William Pearce  
Vice President724-682-5234  
Fax: 724-643-8069April 13, 2005  
L-05-069U. S. Nuclear Regulatory Commission  
Attention: Document Control Desk  
Washington, DC 20555-0001**Subject: Beaver Valley Power Station, Unit No. 1  
BV-1 Docket No. 50-334, License No. DPR-66  
License Amendment Request 320**

This is a request to amend Operating License DPR-66 (Beaver Valley Power Station Unit No. 1). The proposed changes will revise the Beaver Valley Power Station (BVPS) Unit No. 1 Technical Specifications to permit operating with replacement steam generators (Model 54F) installed.

Figure 4.1-5  
REACTOR CORE SAFETY LIMIT  
THREE LOOP OPERATION  
(Technical Specification Safety Limit 2.1.1)

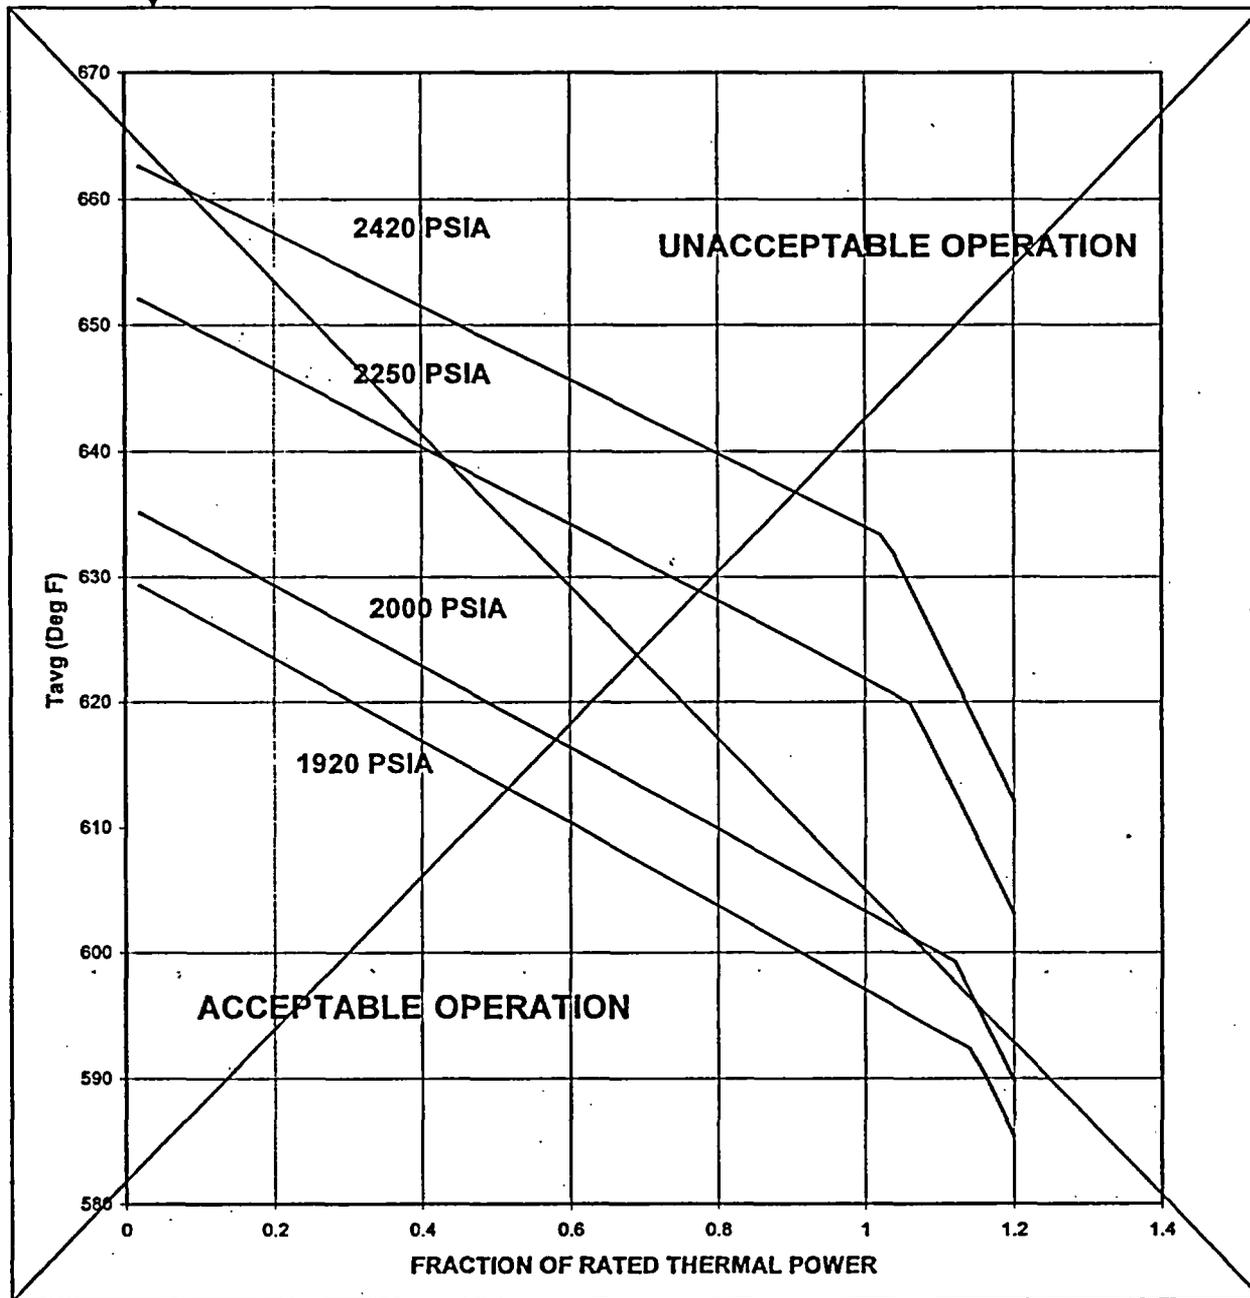
This proposed change is a modification to TS 2.1.1.1, "SAFETY LIMITS – REACTOR CORE." The modification consists of specifying the departure from nucleate boiling ratio (DNBR) for two different departure from nucleate boiling (DNB) correlations. For Vantage 5H (V5H) fuel assemblies, the correlation is WRB-1, and the DNBR shall be maintained  $\geq 1.17$ . For Robust Fuel Assemblies (RFA), the correlation is WRB-2M, and the DNBR shall be maintained  $\geq 1.14$ . This proposed change is reflected in the TS Bases and LRM.

Although not a matter for NRC approval, the TS Bases is further modified by adding a reference to the Revised Thermal Design Procedure (RTDP) approved by BVPS Unit No. 1 License Amendment No. 239 (Reference 9) and the applicable correlations (WRB-1, WRB-2 and WRB-2M) for DNBR analyses. A discussion of the application of the Standard Thermal Design Procedure (STDP) and the applicable correlations (W-3 and WRB-1) is also provided in the TS Bases. The reference to RTDP and the discussion of the application of STDP do not require any change to the TS or LRM. This information is added to provide clarification regarding the application of these two methodologies. The inclusion of the reference to the W-3 and WRB-2 correlations is conservative with respect to the fuel assembly specific DNBR limits of TS 2.1.1.1.
